PCN	Product Change Notification	De-23-011-0719	
Product	SMC	Date of Publication:	
		10.11.2023

**Title:** SMC Tolerance adaption

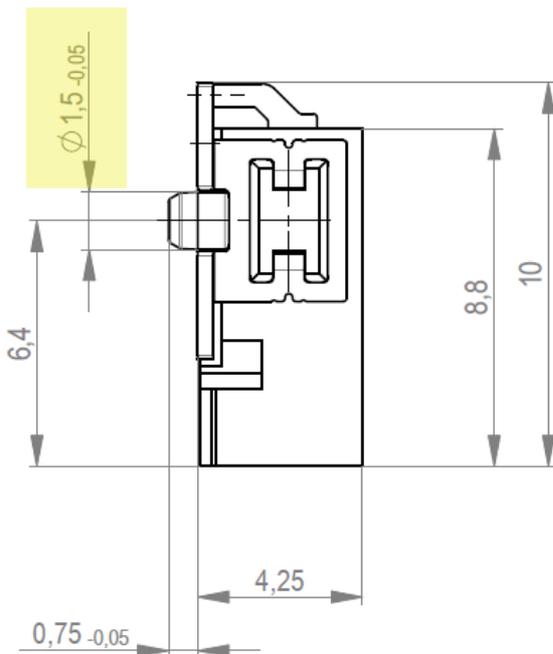
Valued customer,  
for the article numbers listed below a new revision of the customer drawing is available. We have adapted the following tolerances to the real state of the part (see yellow marking).

354097-E: new: 1.5 - 0.05mm (old 1.5mm - 0.03mm)

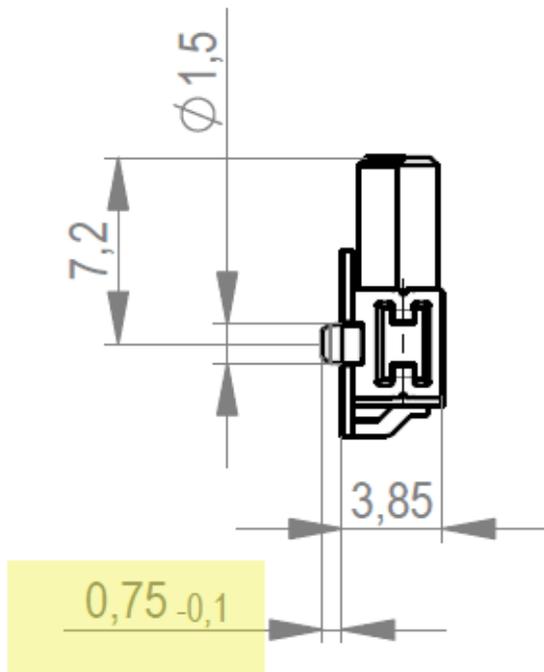
For the following article numbers we adapted the tolerance of the pig length: new 0,75mm - 0.1mm (old 0.75mm - 0.05mm)

154740-E; 154741-E; 154742-E; 154743-E; 154744-E; 223727-E; 225036-E; 284039-E; 294954-E; 354078-E; 354079-E; 354080-E; 354081-E; 394396-E; 394963-E; 474968-E
